Service Bulletin

Bulletin No.: 22-NA-009

Subject: Information on New Torque Specification and Installation Procedure for ACDelco Spin-On Oil Filters

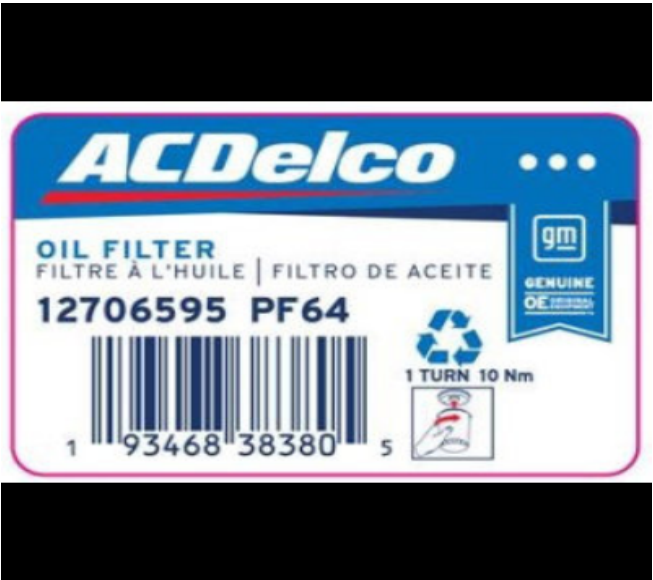
Involved Region or Country	North America, Europe, Uzbekistan, Russia, Middle East, Iraq, Israel, Palestine, Argentina, Brazil, Bolivia, Chile, Colombia, Ecuador, Paraguay, Peru, Uruguay, Venezuela, Japan, Cadillac Korea (South Korea), GM Korea Company, China, Taiwan, Thailand, Singapore, Philippines, Australia/New Zealand, Egypt, Other Africa, South Africa
Condition	Some customers or dealers may comment on an oil leak coming from underneath the front of the vehicle after a prior oil service was performed. This leak can take several thousand miles to occur.
Cause	This may be caused by an oil leak coming from between the oil filter gasket and mounting surface. – Technicians may also notice that the filter is very easy to remove and can sometimes be removed by hand.
Information	<p>To correct this condition, engineering has released a revised installation specification for all Spin-on oil filters. The new specification will be as follows:</p> <ol style="list-style-type: none"> 1. Lubricate the NEW oil filter gasket with clean engine oil. 2. Install Oil Filter 1 full turn after gasket makes contact with the sealing surface on the filter mounting flange. If installing with a torque wrench, this should be approximately 10 N•m of torque. <p>This installation specification will be updated in Service Information (SI) and the label on the oil filters (example shown below) will be updated as well.</p>
